EARLY DESIGN GUIDANCE Analytic Design Proposal Packet

1145 10th Ave E

A Proposed Apartment Development
for Continental Properties, LLC.

EARLY DESIGN GUIDANCE OF THE EAST DESIGN REVIEW BOARD

SEPTEMBER 24TH, 2011 EDG RESPONSE

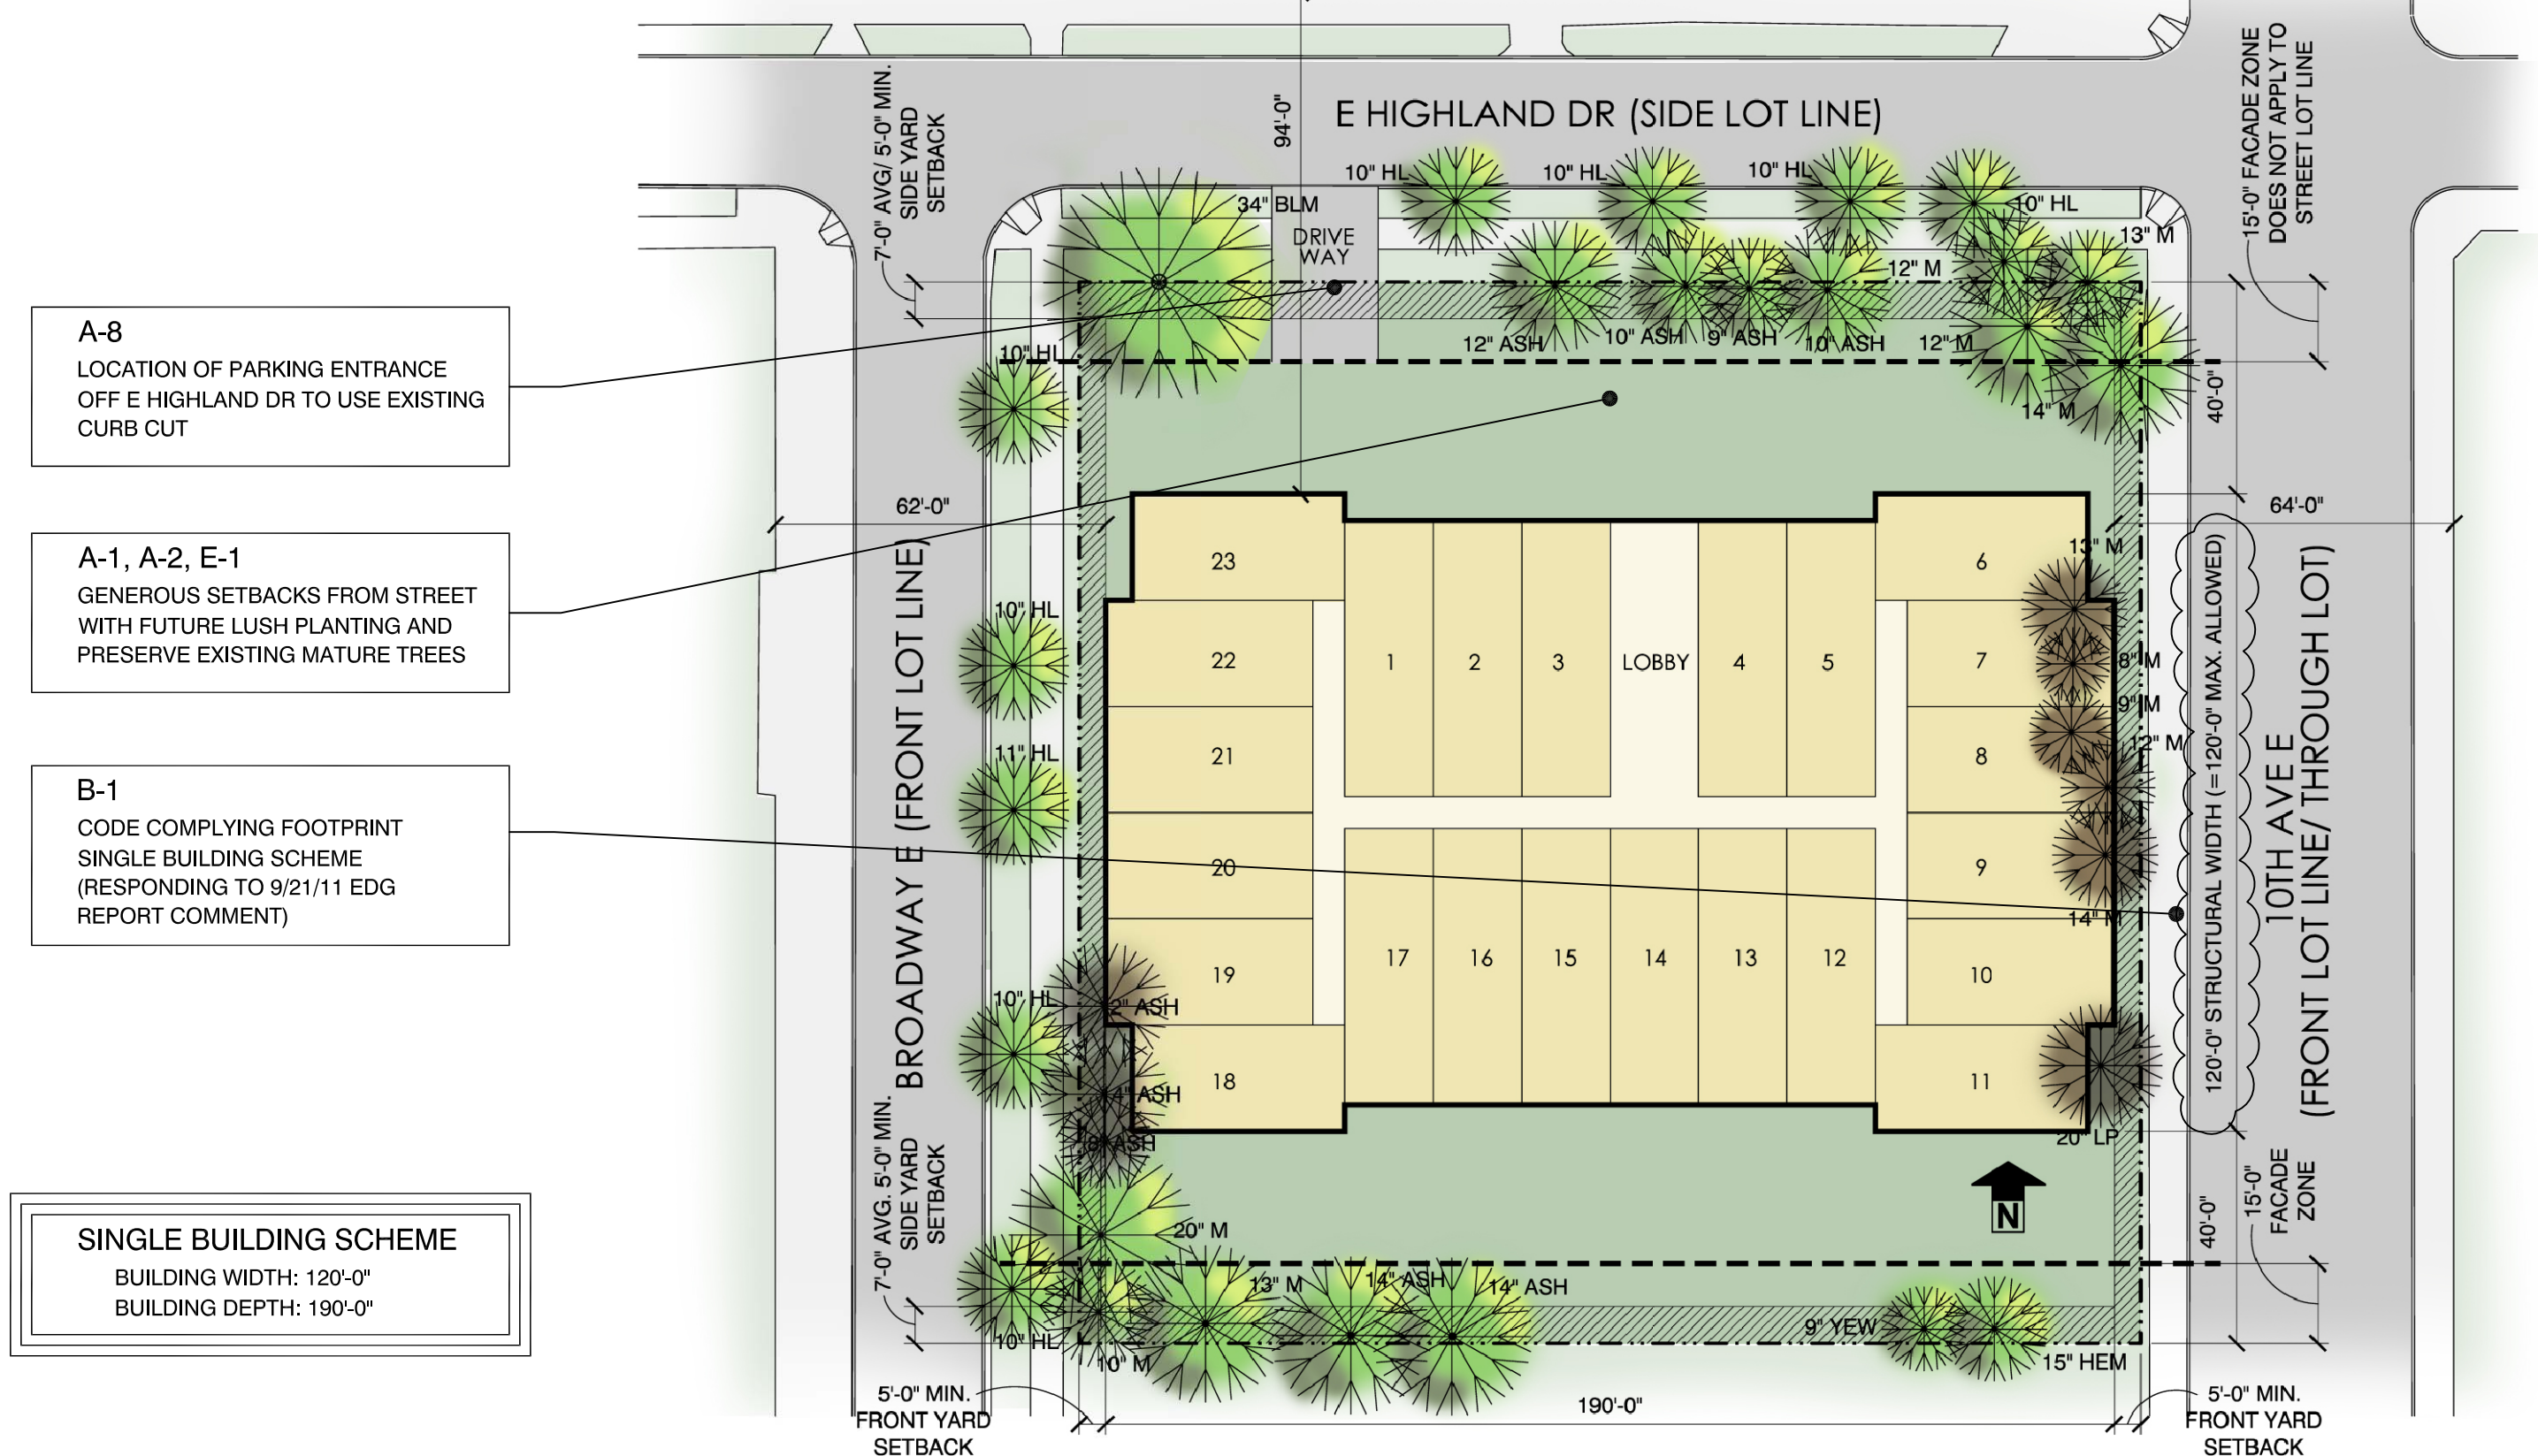
Addressing EDG Comments from 9/21/2011 Meeting

The Applicant has reduced the proposed project to a structure containing only 70 dwelling units with an underground garage with parking for 87 vehicles (a ratio of 1 car per bedroom or 1.24/dwelling). All service areas are provided below grade away from the public view.

The Applicant is presenting 3 alternative design scenarios, two of which do not require any departures and one that requires a departure for increased structure width. All three alternates have shifted the vehicular access of the underground garage to the existing curb cut on E Highland Dr. All Alternates respect the minimum front, rear and side setbacks. The pedestrian access to all three options can be accommodated through E Highland Drive. Option 1 presents a compliant one monolithic building distributing the open areas in two, one to the north along E Highland Dr. and one to the South towards the neighbors. Option 1 preserves the perimeter trees along the north and south edges, but loses trees along the East and West boundaries. Compliant Options 2A and 2B present two long narrow buildings with an interior courtyard. Most of the open areas are concentrated in the center courtyard to provide separation in between each building with code compliant setbacks to the front, rear and sides. Options 2A and 2B have the most significant impact on existing trees, requiring the removal of approximately 70% of the trees bordering the property lines. Option 3 is a single L shape staggered building that requires an increased width departure. The two wings of the L face 10th Ave E and E Highland Dr. This L shaped staggered option distributes the open space to 3 sides of the structure, minimizing the perceived size of each facade and preserving 85% of the trees along the property lines. Option 3 is the Owners preferred option.

- Reduces effective ROW Façade to 105 ft. by recessing portions of the building along 10th Ave E and E Highland Dr., as well as cutting the corner of the building in a diagonal at the intersection of the same streets.

- We have rotated the building 90 degrees and moved the courtyard to have a southwest orientation that will take advantage of the afternoon sun. This move also preserved eight mayor trees on the south west property corner.
- The new staggered design distributes the open space to 3 locations. The east and north elevation will benefit from a larger setback (minimum 15' up to 25' deep) and allow for private patios for the residents as well as an enhanced separation with the neighbors across the street. The diagonal cut at this street intersection allowed the preservation of some important trees. The 3rd area is the courtyard now oriented in the south west direction. It will be a more tranquil space with better sunlight.
- The planting area inward of the sidewalk has been retained and enhanced.

- The access to the underground garage was been relocated to the existing curb cut on E Highland Dr. This move has addressed the concerns of the Broadway residents as well as minimizes the impact on any trees that might have been in a new curb cut location.
- The owner is still requesting a departure of the minimum drive way with, because (although not necessary) he believes is an enhancement to the neighborhood.

DESIGN PROPOSAL- OPTION 3 (PREFERRED SCHEME)

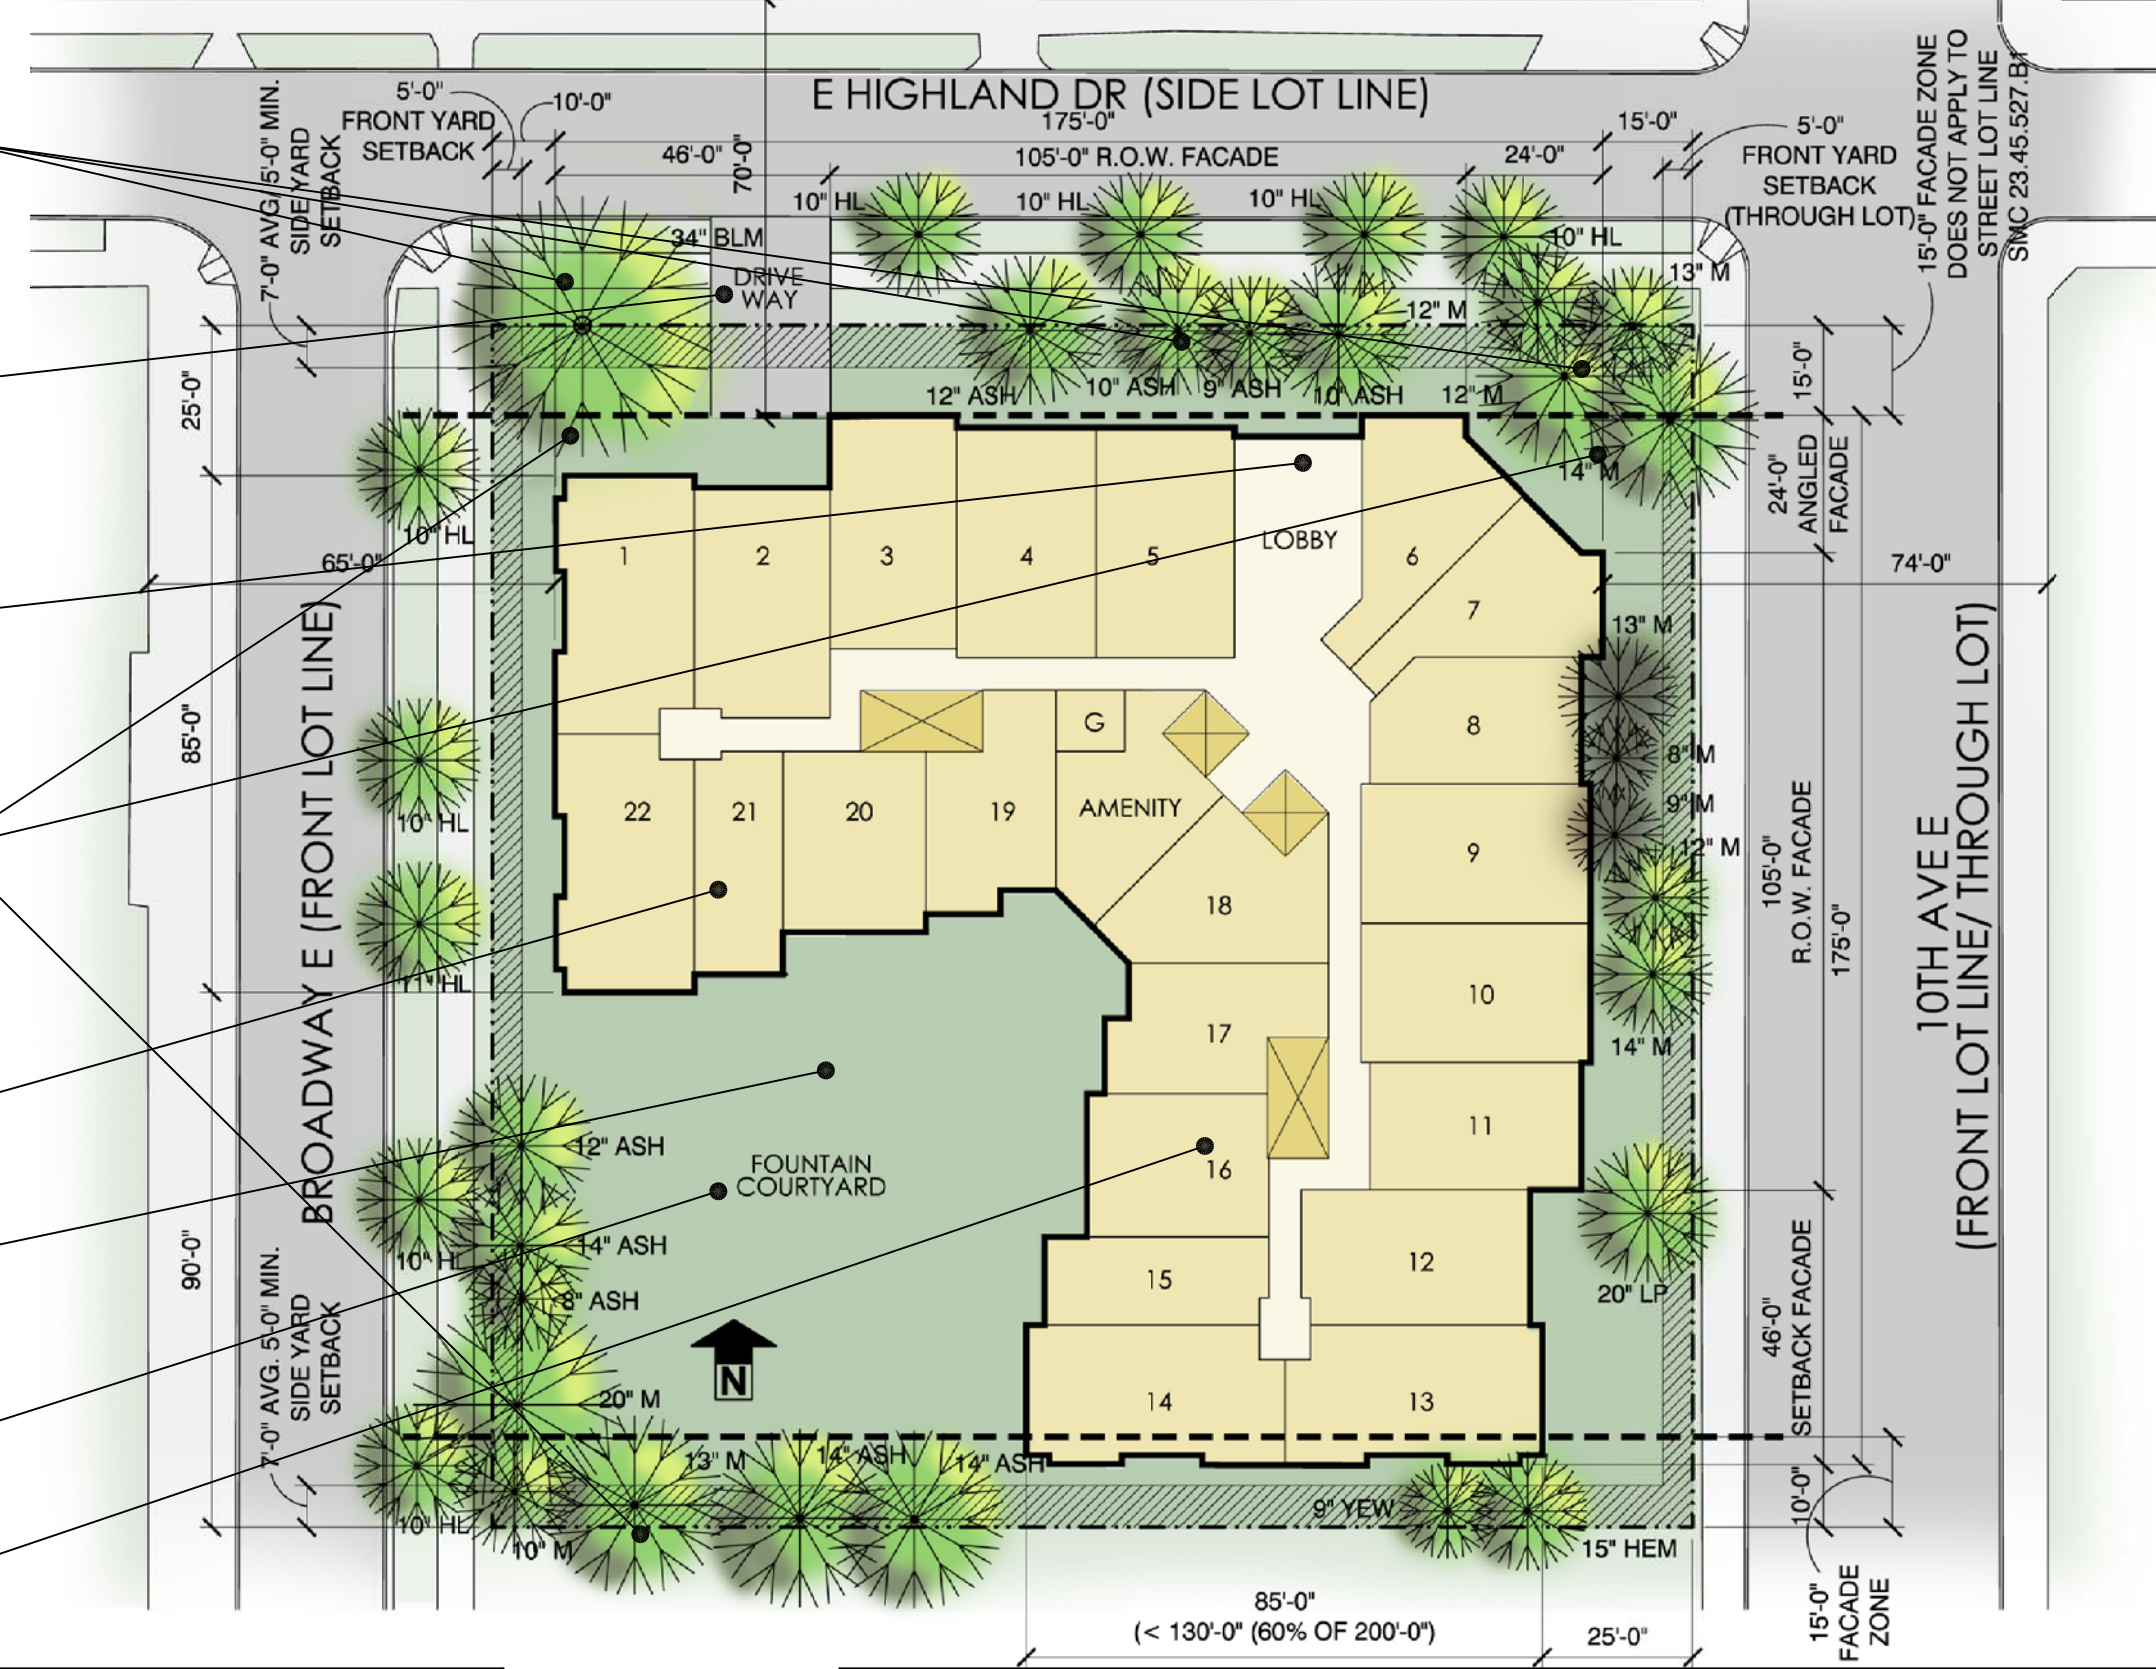
A-5, B-1
RESPECT FOR ADJACENT PROPERTIES. PROVIDE SENSITIVE TRANSITION TO CREATE A STEP IN PERCEIVED BULK AND SCALE

B-1, C-1
MASSING ORIENTATION CREATE SAME SENSE OF INTIMACY OF BROADWAY E

A-8, C-5, D-5, D-6
LOCATION OF PARKING ENTRANCE OFF E HIGHLAND DR TO USE EXISTING CURB CUT. GARAGE ENTRANCE IS MINIMIZED BY BEING ON THE LOW END OF THE SITE. PARKING IS PROVIDED BELOW GRADE AND HIDDEN BY LANDSCAPING. ALL SERVICE AREA ARE PROVIDED AWAY FROM PUBLIC VIEW, BELOW GRADE IN THE PARKING GARAGE.

A-1, A-2, C-1, D-3, E-1, E-2
GENEROUS SETBACKS FROM STREET AND DISTRIBUTION OF OPEN SPACES WITH FUTURE LUSH PLANTING AND PRESERVE EXISTING MATURE TREES. GENEROUS SETBACKS ALSO ALLOW MINIMIZING RETAINING WALLS AND ARE DESIGNED TO INCREASE THE VISUAL INTEREST ALONG THE SIDE WALLS

A-7, D-1, E-2
MAXIMIZE OPPORTUNITIES FOR CREATING USABLE, ATTRACTIVE, WELL OPEN SPACE

RATIONAL #1: CONTIGUOUS USEABLE OPEN SPACE ADJACENT TO PEDESTRIAN STREET

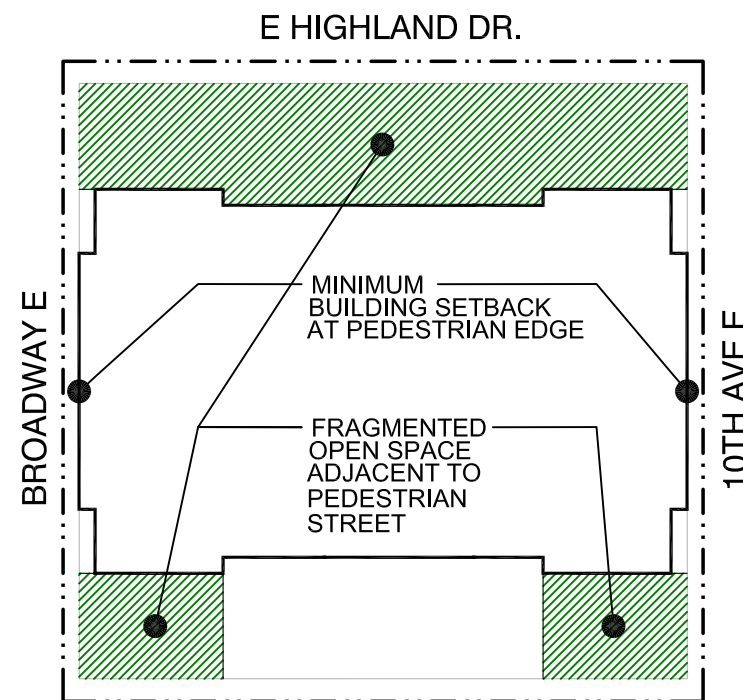
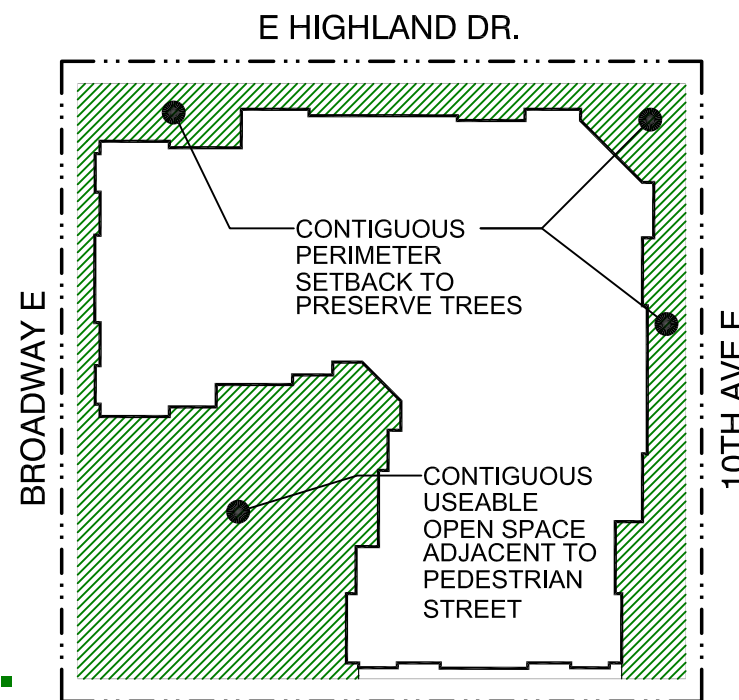
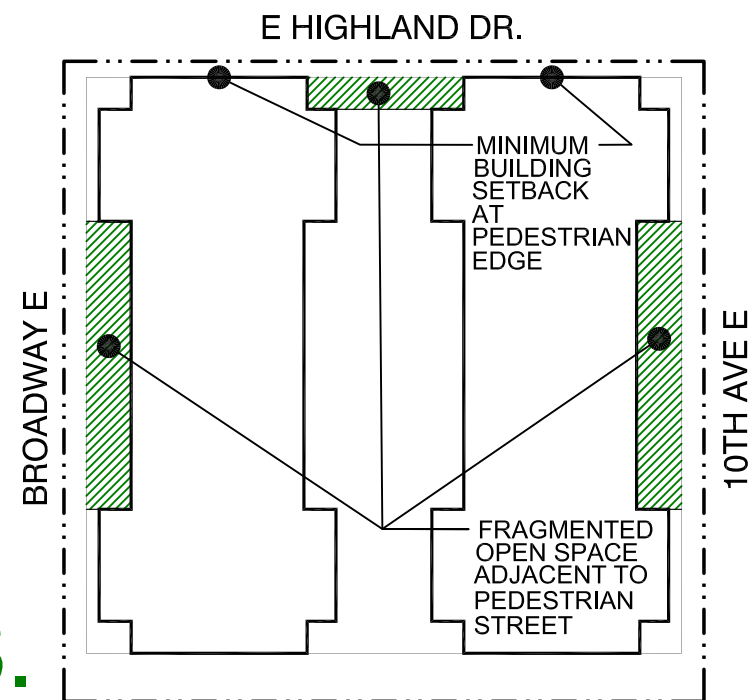
#	Code Requirement	Departure Requested	Explanation for Departure
1	SMC 23.45.527 Table A Maximum Structure Width for apartments in LR3 Zone outside Urban Villages, Urban Centers or Station Area Overlay Districts= 120 ft	Increase allowed maximum structure width from 120 ft to 175 ft.	This departure enhances the urban quality of the project at the street front and allows for larger contiguous useable open space adjacent to the pedestrian street. Please see diagram below.
